MEMORANDUM

FILE NO.: CSP2012 0003

PROPOSAL: A City Consistency permit for the renovation of Auke Bay Elementary School.

Figure 1: Pictured above is the Auke Bay Elementary School and main parking lot. The drop-off/ pick-up lane forms around the parking lot. The entrance and exit are through a single driveway to Glacier Highway. Picture provided by Google Earth Street View, dated 2010.

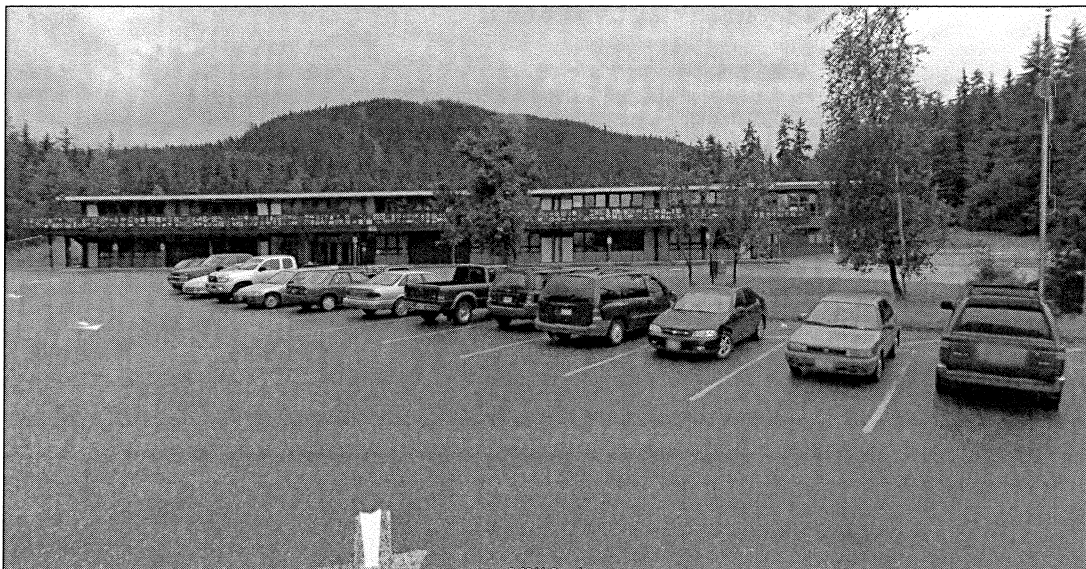
As seen in Figure 1, the existing building is two stories in height. The second story partially sits on a small hill that is 10 feet higher than the first floor. Though the number of stories will not change with the proposal, two mechanical rooms (penthouses) are proposed at a third-story level; See sheets A301 & A302 of Attachment C. Measuring from the lowest point of the foundation to the top of the penthouse at the southern facing side it is 42 feet high. The Land Use Code provides flexibility when developing on a hillside. Per CBJ § 49.25.420 *Height of Building*: if the difference between the lowest and highest foundation points exceeds 10 feet, then 10 additional feet is added to the lowest point. Therefore, 10 feet above the lowest point is the starting elevation for the measurement. Applying this calculation, the height of the building is 32 feet and complies with the height limit of the zoning district.
